**TO:** District of Columbia Zoning Commission  
*JLS*

**SUBJECT:** **Hearing** Report - ZC #14-18 (Brookland Manor)  
First Stage and PUD and Related Map Amendment

### Generalized Policy Map

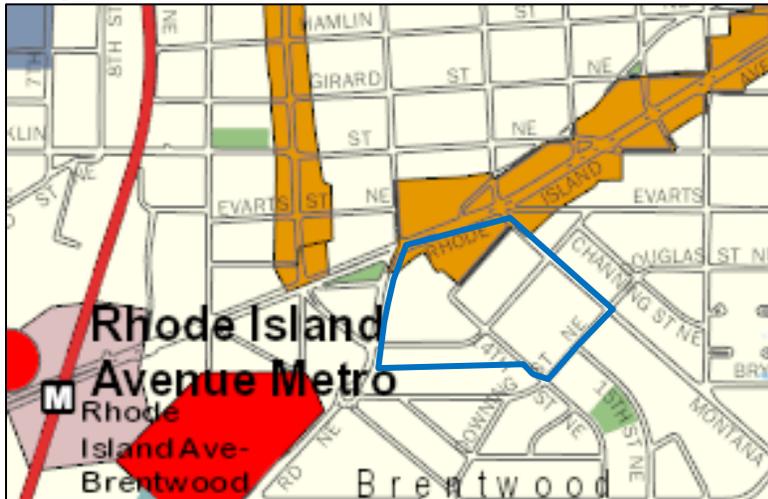
The Generalized Policy Map designates the area as a Neighborhood Conservation Area and along a Main Street Mixed Use Corridor.

The proposed C-2-B/PUD introduces density and heights that are greater than those recommended under moderate density. The proposed C-2-B and C-2-A mixed use buildings within the PUD extend commercial uses well into the residential designated area and are also difficult to rectify with the existing classification of Neighborhood Conservation Area which in this case is residential use.

Map 5 – Proposed Zoning

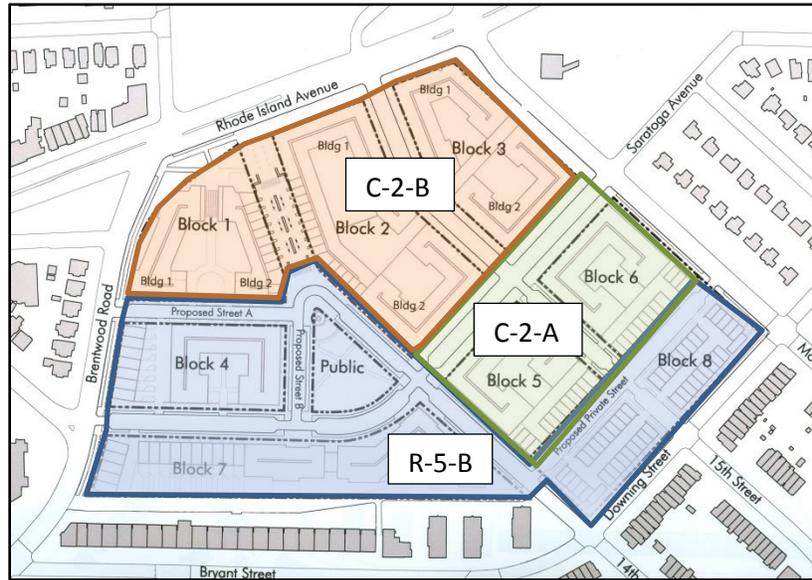
As shown on the map below, the applicant has requested the following PUD-related map amendments:

- Blocks 1, 2 and 3, planned for the mixed use buildings with retail and apartment uses in the C-2-B zone;
- Blocks 5 and 6, planned for mixed use buildings with retail, apartments and rowhouses and would be in the C-2-A zone; and

- Blocks 4, 7, and 8, planned for a mix of apartments and rowhouses and flats in the R-5-B zone.
